# TP-LINK CORPORATION PTE.LTD.

Subject: Requesting Class II permissive change for FCC ID: 2BCGWBE700

P20 Schematics the transformer model change from HST-36001AR to HST-36001DAR.

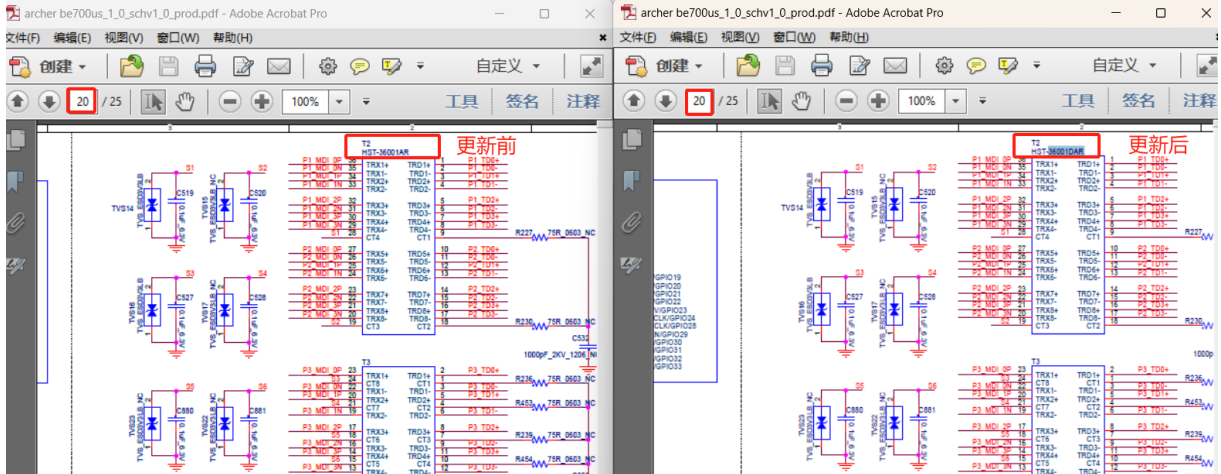
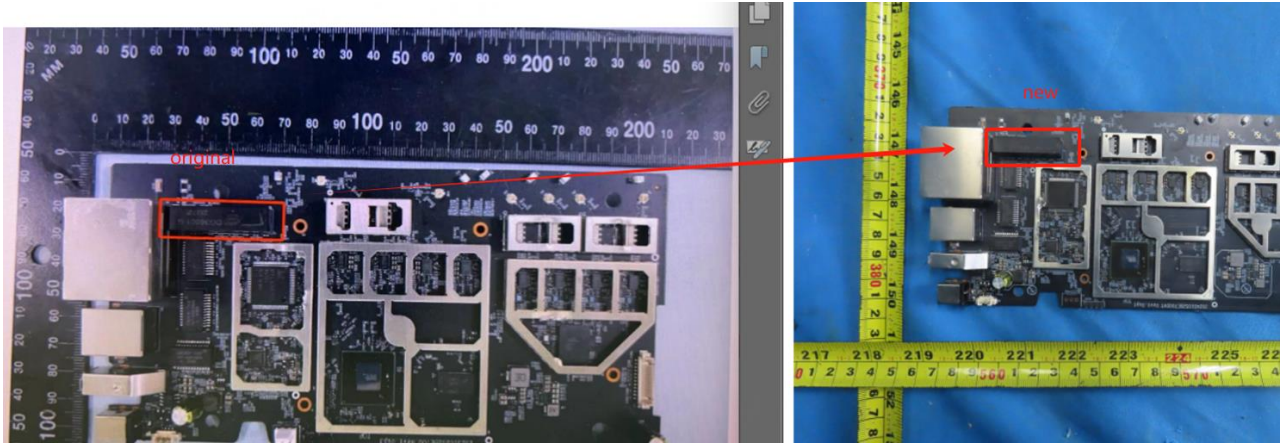
1. Just model Archer BE700 changed the signal transformer of the network port.(Update transformer model number.)
